Access Compliance Report

Public Rights-of-Way

(Curb Ramps)

Intersection ID: 49277	Main Street: REUNION_ST	Cross Street: HOMECOMING_WY	Location: NE
ADA ID: C3891D7FE07F	Ramp Type: PerpDiag	Initial Pass/Fail: Fail	Overall Compliance: No
Severity Score: 13.75			
Codes/Mitigation Info/Possible Solution		Field Measurements/Component Compliance

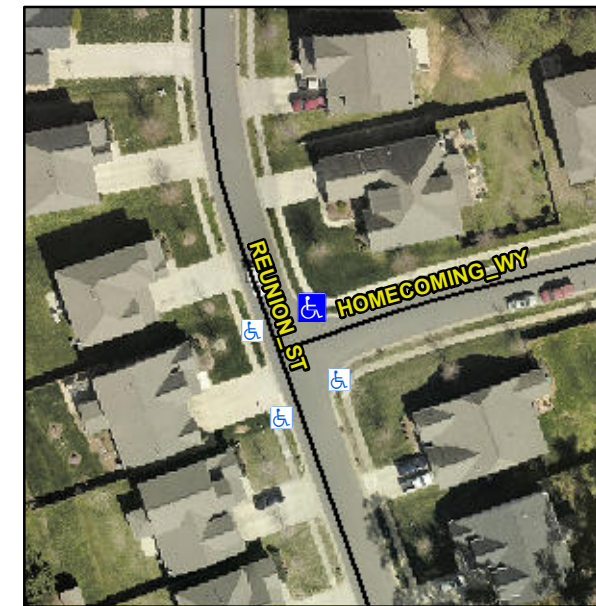
Compliance	Description	Data	Compliance	Description	Data
N/A	Ramp Length (in)	47.5	No	Ramp Slope (%)	9.9
Yes	Ramp Width (in)	48.0	No	Ramp XSlope (%)	4.9
N/A	Flare Type LT	N/A	N/A	Flare Type RT	N/A
N/A	Flare Slope LT (%)	N/A	N/A	Flare Slope RT (%)	N/A
N/A	Flare Traversable LT?	N/A	N/A	Flare Traversable RT?	N/A
N/A	Landing Length (in)	N/A	N/A	DWS Provided?	N/A
N/A	Landing Width (in)	N/A	N/A	DWS Contrast?	N/A
N/A	Landing Slope (%)	N/A	N/A	DWS Length (in)	N/A
N/A	Landing X Slope (%)	N/A	N/A	DWS Full Width?	N/A
N/A	Landing Curb? (Y/N)	N/A	N/A	DWS Offset (in)	N/A
N/A	Shared Landing?	N/A			
N/A	Gutter Ponding?	N/A	N/A	Gutter Slope (%)	N/A
N/A	Gutter Lip Ht (in)	N/A	N/A	Gutter X Slope (%)	N/A
N/A	Painted X Walk1?	No	N/A	Painted X Walk2?	No
	X Walk 1 Direction	To W		X Walk 2 Direction	To S
N/A	X Walk 1 Width (in)	N/A	N/A	X Walk 2 Width (in)	N/A
	X Walk 1 Slope (%)	1.6		X Walk 2 Slope (%)	4.9
	X Walk 1 X Slope (%)	5.4		X Walk 2 X Slope (%)	4.2

N/A	Ramp inside XWalk1?	N/A	N/A	Ramp inside XWalk2?	N/A
	Road Slope (%)	4.7	N/A	Clear Space?	N/A
	Road X Slope (%)	3.1	N/A	Clear Space to XWalk (in)	N/A
N/A	Any Obstructions?	N/A	N/A	Storm Grate/Utility Hazard?	N/A
	Obstruction Type			Storm Grate/Utility Type	
		N/A			N/A
			Yes	Surface Condition? (G/P)	Good

Remove & Replace Curb Ramp With Two New Directional Ramps or Equivalent.
